GFA AIRWORTHINESS DIRECTIVE

TYPE AFFECTED: ASW 27. All models and serial numbers.

SUBJECT: Check of control circuit clearance inside the fuselage tail boom to fin intersection.

Fig. 1A

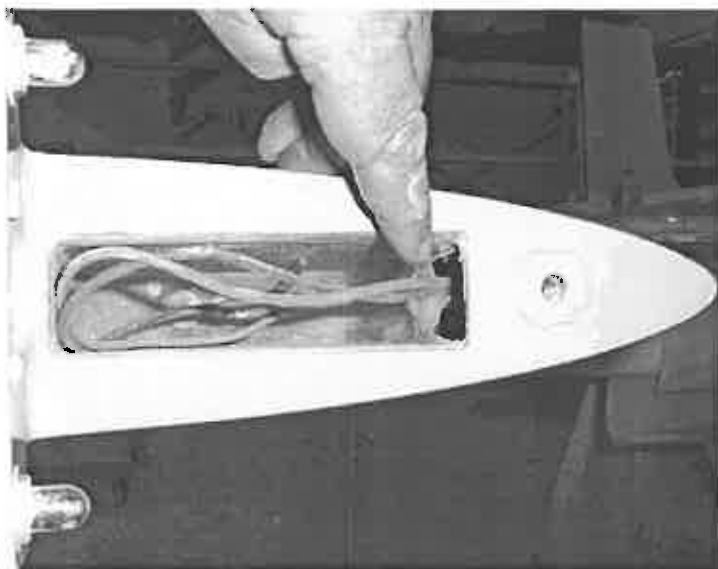
- Action:**
- 1) De-rig the horizontal tailplane, look through fin ballast box as shown in Fig. 1A and check the clearance left and right of the mass balance weights, see Fig. 1B. A strong light which is held to the outside of the fuselage to fin intersection close to the critical area improves the visibility remarkably.
NOTE: The critical situation is reached, when the elevator actuator is fully down. When the clearance (including bolt head and nut or bolt end) is about symmetric and 2,5 mm (1/10 inch) wide, no further action is needed.

Fig. 2

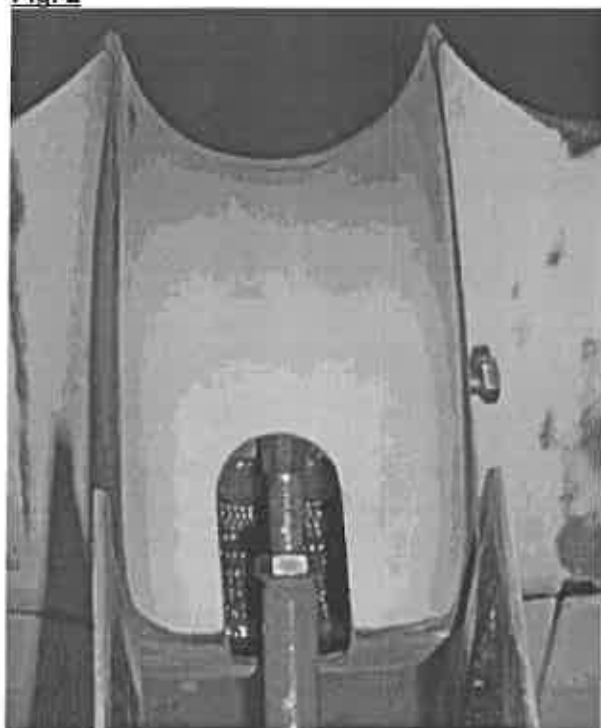
- 2) When the clearance is insufficient, the situation can be remarkably improved by rotating the 90° lever forward and downward. To accomplish that, the bolt at the elevator actuator must be removed and the universal joint must be turned into the push rod so that it gets shorter, see Fig. 2. To compensate the adjustment in length, the push rod at the left hand side of the cockpit must also be shortened by the same number of threads. To get to the push rod the cockpit seat pan must be removed, see Fig. 3. When the threads at the cockpit push rod are not sufficient to get enough clearance at the lever, the front push rod may be shortened by an authorised welder for aircraft components.

Fig. 3

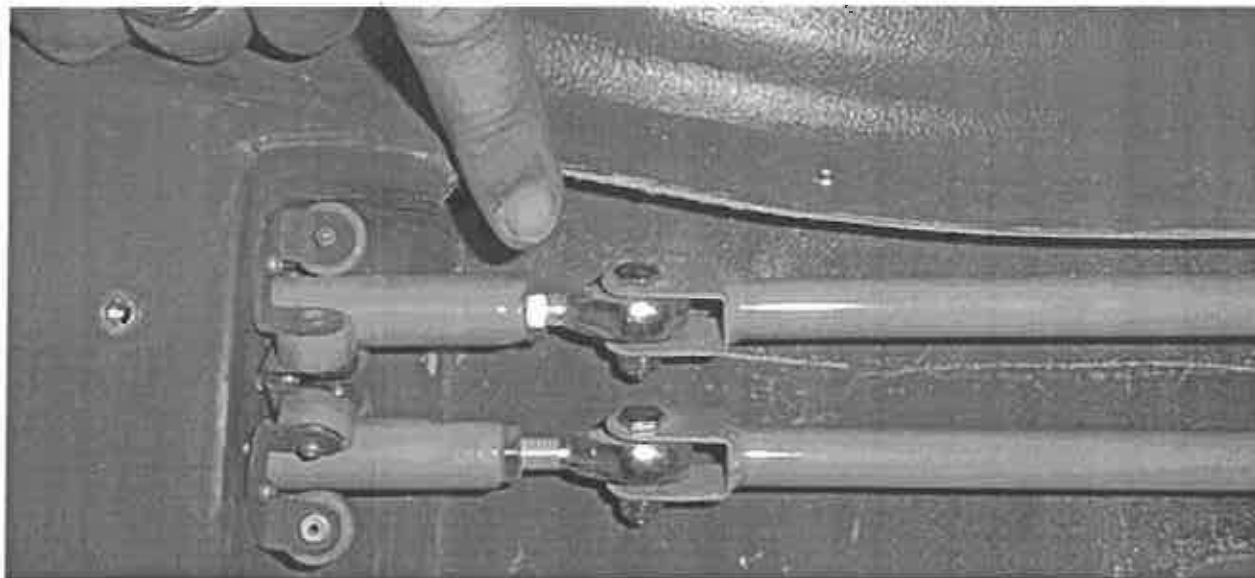
- 3) When action according to 2) was necessary, the elevator deflections must be checked and be adjusted within the tolerances given in the Maintenance Manual, page 3.2. Now the adjusted control components must be safetied and checked (see also the other problem areas marked in Fig. 3 and 4 and reinstall the seat pan.
